U. S. ARMY AC-1 DE HAVILLAND "CARIBOU" EVALUATION
Ft. Rucker, Alabama
21 January 1960

REPORT OF CRASH INJURY EVALUATION
A/CIR-14-PV-121
October 1960

A crash injury evaluation of the DeHavilland DHC-4, U. S. Army AC-1 DH "Caribou" was conducted by AvCIR, a division of the Flight Safety Foundation, on January 21, 1960, at the request of the U. S. Army Transportation Research Command (TRECOM).

Figure 4. Front view of Caribou.

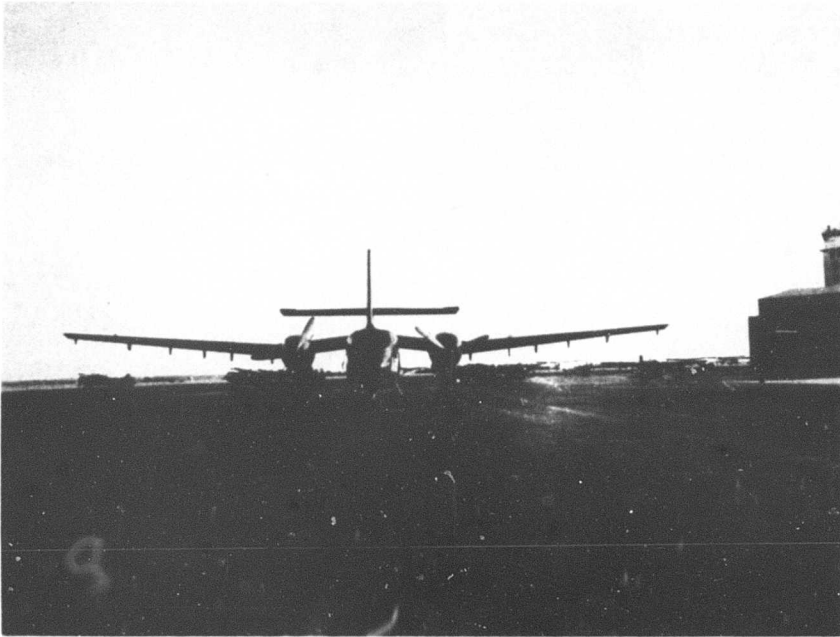
This gives the basic aircraft structure its main strength in the inverted U formed by the main landing gear and the connecting wing center section (Figure 4) and indicates the advisability of making a crash landing with the main landing gear extended, regardless of terrain.

Therefore, a flat terrain should be selected and the aircraft should be flown in rather than dropped in to prevent crushing of the cabin compartment by the heavy super-structure.

1. If conditions permit, crash landings be made with the landing gear extended, regardless of the terrain used.
2. If landing gear malfunction dictates a wheels-up landing, flat terrain be selected and the landing technique be aimed at minimum vertical load at touchdown.

Figure 5. Pilot's seat.

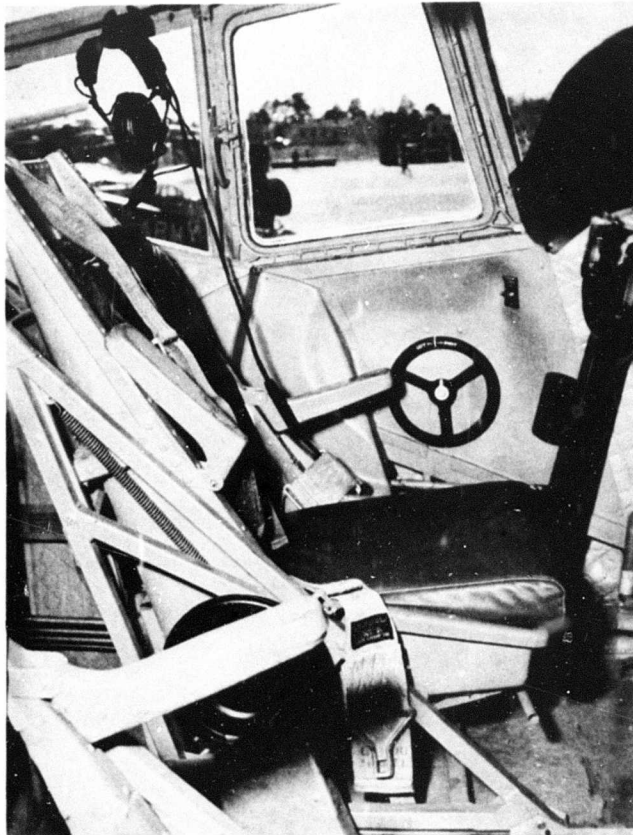
Attachment of the seat belt and shoulder harness to basic aircraft structure would relieve the seat of much of the crash load during crash deceleration and offer some form of occupant protection even when the seat tie-down failed. On the other hand, it is realized that this would entail certain inconveniences for the occupant because vertical seat adjustment would always necessitate seat belt adjustment while shoulder harness adjustment might be necessary before or after vertical and/or horizontal seat adjustment. Based upon this analysis, it appears advisable to have the seat belt attached to the seat as presently attached.

The manner of shoulder harness attachment cannot so easily be decided. The advantage of attaching the shoulder harness to basic aircraft structure is unquestionable since it eliminates the torque on the seat exerted by a shoulder harness anchored to the seat. This advantage must be weighed against some of the problems that may be encountered.

The vertical seat adjustment system creates a hazard under certain conditions. A person (crew chief or troop commander) standing in the aisle behind and below the crew seats would probably support himself by placing his hand against the open frame work in which the seat moves up and down. This would expose his hands to injury in case of vertical seat adjustment by one of the crew members.

3. The width of the shoulder harness guide on top of the crew seat backs allows too much lateral movement. This may result in serious contact-injury during side load conditions.

2. The width of the shoulder harness guide on top of the crew seat backs be reduced to increase lateral support during side load conditions.
3. The inertia reel in the Caribou be replaced by a model that ensures positive locking of the shoulder harness regardless of the direction of crash force.

4. Consideration be given to anchoring the shoulder harness to basic aircraft structure in a manner that precludes undue inconvenience to the crew members.

5. The inboard sides of the crew seats be shielded in a manner that precludes injury to a person supporting himself against these seats.
6. The present ultimate sideward and upward load characteristics of the crew seats be re-evaluated to determine whether these loads are compatible with the forward strength characteristics of the seats.

Figure 7. Left side of the cockpit, showing the stowable radio console between the pilot's and copilot's rudder pedals (arrow).

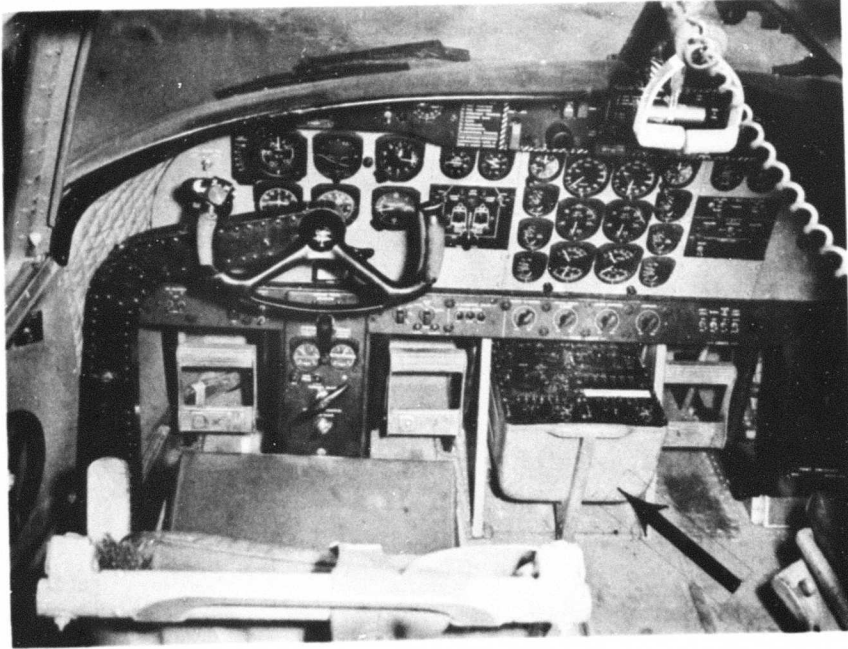
Although the tie-down strength of this console could not be accurately assessed, it can be stated that its resistance against abrupt decelerations should be at least equal to that of the crew seats to prevent it from becoming a dangerous projectile or imposing an additional load on the adjacent seat attachments.

1. The cockpit has several desirable features which reduce the number of objects within striking range of the crew.
2. The stowable radio console would constitute a serious hazard if it became dislodged.

1. The tie-down strength of the radio console in the fore and aft position be subject to a critical examination to determine its compatibility with the tie-down strength of the crew seats.

Figure 10. The two auxiliary ramps (1 and 2) are stowed against the ceiling in the aft fuselage above the cargo door.

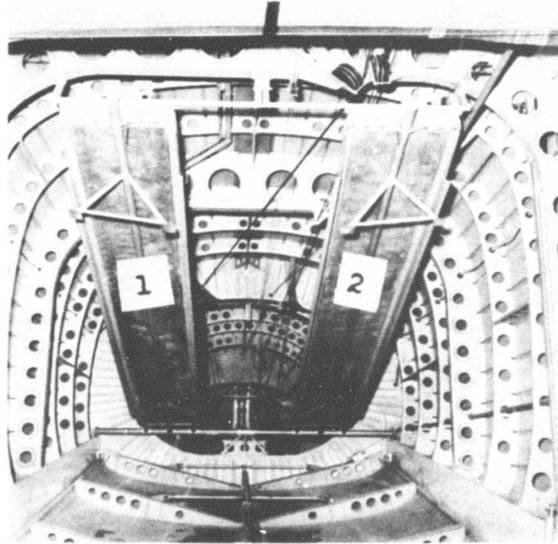
Two auxiliary ramps, to facilitate loading wheeled vehicles, are stowed against the ceiling in the aft fuselage above the cargo door (Figure 10). It is impossible to make an analysis of the tie-down strength of this installation based upon the available data. It can only be stated that these ramps would create a serious hazard for the cabin occupants if they became dislodged as a result of impact forces or distortion of the aft fuselage.

1. The cabin floor forms an excellent platform and will offer considerable crash protection.
2. The two auxiliary ramps, stowed against the ceiling in the aft fuselage, might conceivably become dislodged during a crash deceleration of sufficient magnitude and be hurled into the cabin.

1. The tie-down strength of the auxiliary ramps in the stowed position and the effects of aft fuselage distortion on the present installation be critically examined. (Stowage in the fuselage bottom or sides would simplify the tie-down problem and facilitate ground handling.)
2. The strength of troop seat lap belts and attachments as specified in MIL-S-5705 be increased to approximately 20 G.
3. The present troop seat specifications be subjected to a realistic appraisal in order to determine what steps can be taken to increase occupant protection.

Figure 12. Close-up of a four-man seat. Notice the three legs and their attachment to the floor. The spacing of the holes in the seat back indicates the manner in which variation in seat belt anchorage makes this a variable width seat.

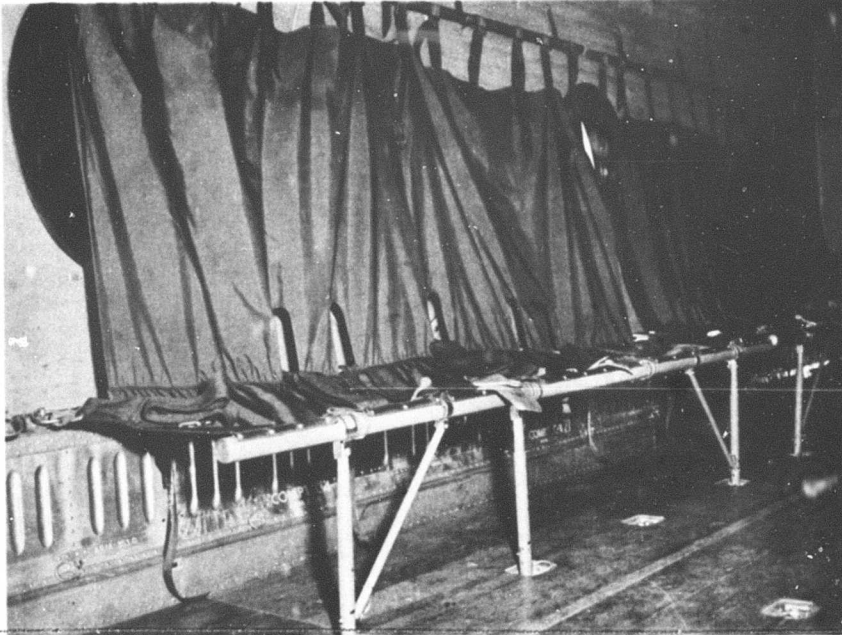
Although the Military Specification specifies tape (webbing) material for the seat back, the seat backs in the Caribou consist of one piece (nylon). This will undoubtedly help to prevent snagging of the equipment carried by paratroopers (Figure 12).

The strength requirements in both specifications are similar, with the exception of the seat bottom (11 G vs. 10 G). The load on the seat bottom may be considered equally distributed over the rear and front support tubes (Figure 13). This leads to some interesting speculations on the loading of the seat legs. According to the specification, the load carrying capacity of these legs is 1,000 pounds each. Making the conservative assumption that not more than half the occupant's weight is supported by the seat legs this would give the legs a 10 G strength. However, for a three-man seat the center leg is optional which implies that the resistance against vertical loads would be reduced to about 6.5 G ($\frac{2,000}{300}$). In the same manner the strength of a four-man seat with three legs, as used in the Caribou, would be reduced to 7.5 G.

Figure 14. Post-crash appearance of seats built in accordance with the same Military Specifications, installed in another aircraft, after a moderate impact. The arrows indicate failures.

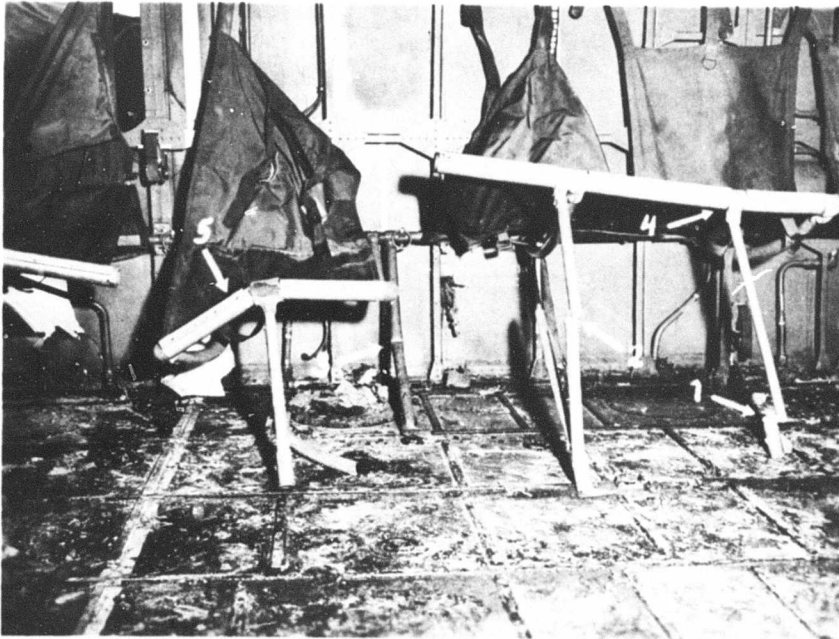
The effect of moderate crash forces on seats of similar design is shown in Figure 14. The seat legs and the front support tube failed in a manner that exposed the occupants to serious injury.

The side load strength requirement for this seat forms the main point of controversy concerning the adequacy of design. The seat is required to withstand an ultimate sideload of 225 pounds (1.1 G) applied in line with the center line of the front support tube. Since the seats are installed alongside the cabin walls (facing inboard), this load is applied parallel to the longitudinal axis of the aircraft and can actually be considered a forward load. In fixed wing aircraft this is often the direction in which a component of the main crash force is applied and for this reason most seats have their greatest strength in the forward direction. The foregoing should make it clear that in the case of the troop seat design requirements the situation is exactly reverse, that is, the seat has its lowest strength in the forward direction.

Figure 17. The seat belts in the Caribou are directly attached to the clamps that secure the rear support tube to the basic aircraft structure (black arrow).

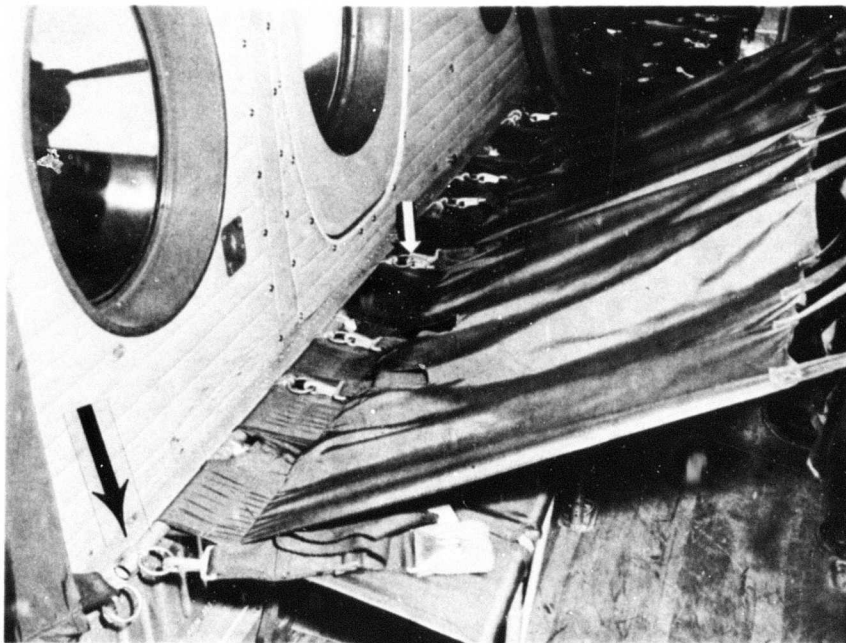
A factor which, to a certain extent, compensates for the lack of adequate forward strength of troop seats is the fact that the seat belt is attached to basic aircraft structure and not to the seat. This seat belt provides protection up to a deceleration of 11 G - (MIL-S-5705). Considering past accident experience, which indicates occasional failure of these seat belts under moderate impact conditions, and the generally accepted assumption that the human G tolerance to abrupt forward deceleration when restrained by a seat belt only, allowing for some minor injuries, is in the 15-20 G range, the required design strength of this seat belt seems inadequate.

The manner in which the seat belts in the Caribou are anchored to basic structure (Figure 17) shows improvement over the anchorages observed in previously evaluated aircraft. The system of the "D" ring and the drilled hole in the rear support tube, which frequently led to failure at these points as indicated by accident experience, is replaced by a clamp around the support tube. At one end this clamp is attached to the basic aircraft structure and at the other end there is a ring for seat belt anchorage.

Figure 18. Litter and troop seat installations.

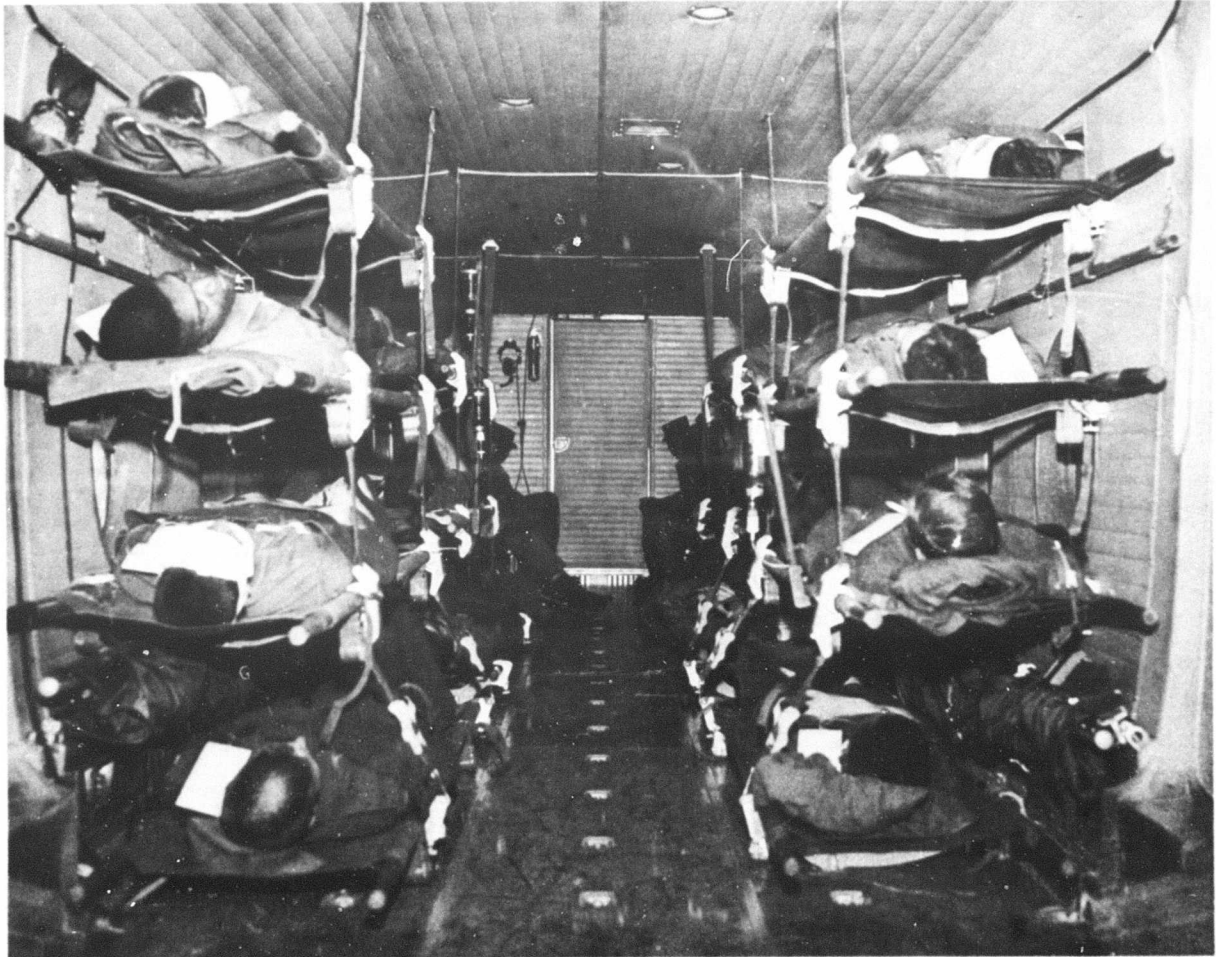
Seven litters, one stack of four and one stack of three, can be installed along both cabin walls (Figure 18). Each litter is mounted in two brackets on the cabin wall and two brackets on litter straps on the aisle side. The litter straps are anchored in the ceiling and in the floor.

In addition to being incomplete, these litter tie-down requirements are inadequate. Not only are they far below the recognized limits of human G tolerance (see Appendix I), but they also offer less crash protection than the tie-down requirements for passenger seats in transport aircraft* which are considered inadequate for survivable impact conditions.

4. The standard litter installation in Army aircraft, as used in the Caribou, be subjected to static or dynamic tests to (a) determine its ultimate load-carrying capacity in relation to the requirements in MILS-5705; and (b) the adequacy of these requirements in relation to survivable crash force conditions.

Figure 19. Emergency exit release of the cockpit escape hatch above the pilot's seat. The black arrow indicates the button that has to be pressed before the handle can be turned. Notice that the instructions do not refer to the button.

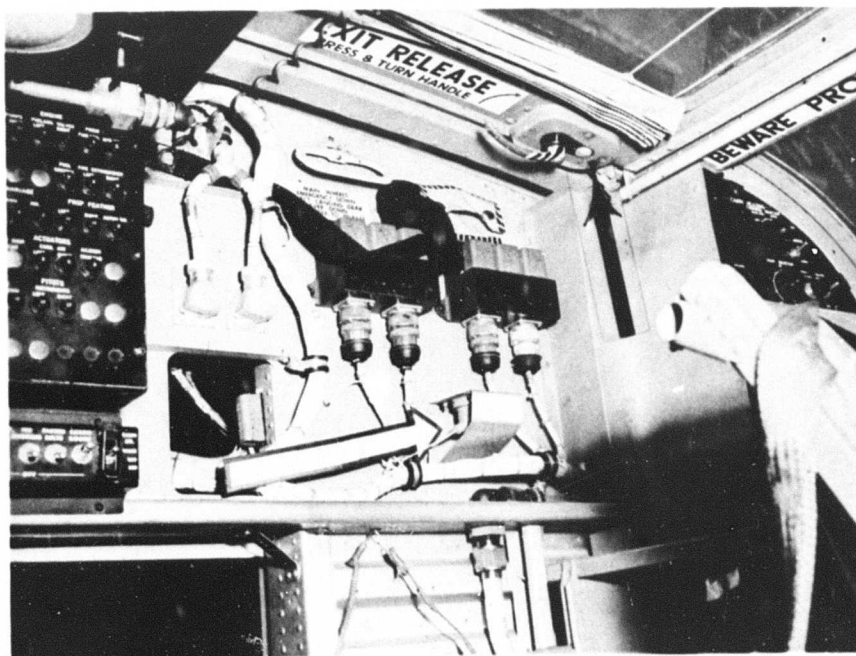
In addition to the bottom entry hatch, which can be jettisoned, there is an escape hatch in the cockpit structure above and behind the pilot's seat (Figure 19). The sliding windows on both sides of the cockpit provide alternate emergency exits. These arrangements plus the proximity of the cabin emergency exits to the flight crew area are adequate to permit rapid evacuation of the crew. To operate the top escape hatch a button must be pressed before the release handle can be turned. This button is rather small and flush with the surrounding surface. Quick manipulation of this button requires attention and accuracy. In conditions of darkness or crew incapacitation this could easily lead to delay in escape time.

Elimination of this button from the sequence of operation would facilitate operation and does not seem to constitute a hazard because the likelihood of inadvertent operation of this exit in the crew compartment by inexperienced personnel is practically non-existent.

1. The operation of the outside release of the emergency exit and the cockpit escape hatch be simplified by elimination of the button manipulation.
2. If these buttons are to be maintained, the related instructions be made more explicit and leave no doubt regarding sequence of operation and location of button.
3. The doors on opposite sides at the aft end of the cabin be made jettisonable.
4. The relocation of the troop seats with respect to the forward emergency exit (or vice versa) and the exit release handle be considered in order to determine the practicability of making this exit usable without removal of seat structure.

Figure 20. To open the guard covering the exit release of the cabin emergency exit (big arrow), the upper seat support tube has to be removed. This tube also shields the instructions on the guard.

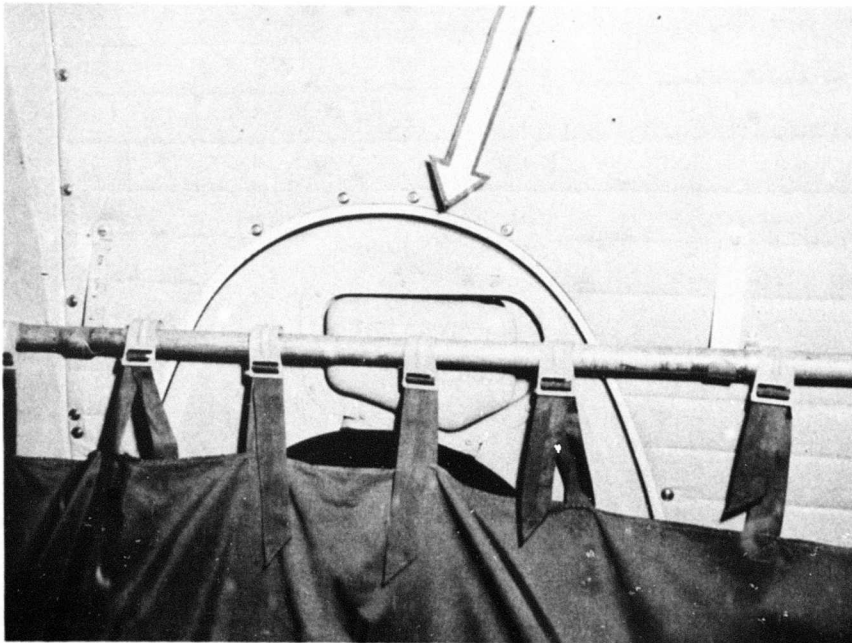
The cabin is equipped with an elliptical emergency exit located on the left side under the left wing. To operate this exit a handle must be turned which is covered by a guard. It will be noted in Figure 20 that this guard cannot be opened unless the upper seat back support tube has been removed. This tube also shields the emergency instructions on the guard. Since the greater part of the emergency exit is covered by the seat backs, it may go unnoticed by less experienced passengers.

The effectiveness of this emergency exit and the ease of operation would be greatly increased if the open space between adjoining seats had been utilized (Figure 21). In addition, if the location of the exit release handle and guard were slightly changed (up or down) with respect to the upper seat support tube, this exit could be used without removal of seat structure.

Figure 22. The two doors on opposite sides at the aft end of the cabin (1 and 2) are not jettisonable.

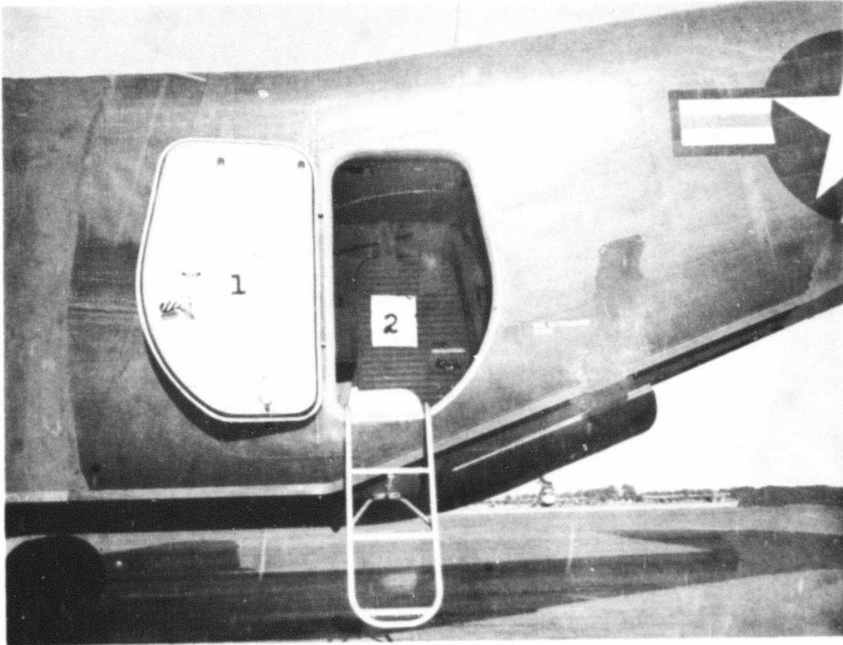
There are two doors (30 x 50 inches) on opposite sides at the aft end of the cabin (Figure 22). Although the one on the right is jettisonable according to the Model Specification, this was not the case in the model that was examined.

If the aircraft came to rest on its left side, two cabin exits might be rendered useless. This, in combination with possible jamming of the cargo door, would leave the cabin passengers with one exit only. The need for an extra emergency exit in the right cabin wall is also indicated in the following extract from the Handbook of Instructions for Aircraft Designers (HIAD - ARDCM 80-1):

2. If these buttons are to be maintained the related instructions be made more explicit and leave no doubt regarding sequence of operation and location of button.
3. The doors on opposite sides at the aft end of the cabin be made jettisonable.
4. The relocation of the troop seats with respect to the forward emergency exit (or vice versa) and the exit release handle be considered in order to determine the practicability of making this exit usable without removal of seat structure.
5. An extra emergency exit be added to the right cabin wall and that its location and design be governed by Recommendation 4 above.

Figure 23. The rear cargo door retracts in the roof structure of the aft fuselage (arrow). It can also be jettisoned.

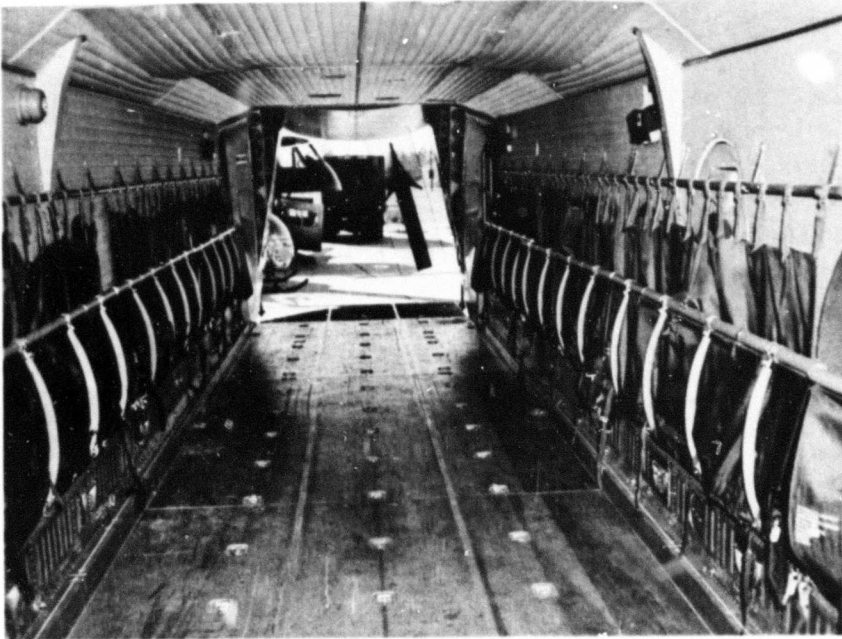
The rear cargo door provides a fourth emergency exit from the cabin compartment (Figure 23). The upper section of this door is jettisonable. The large size of this section and the manner in which it fits in the aft fuselage when in closed position make it very likely that this door will be jammed, when this part of the fuselage is distorted during a crash. Therefore, this door should not be depended upon as an emergency exit unless it is opened or jettisoned before impact. This further indicates the necessity of making both aft exits jettisonable.
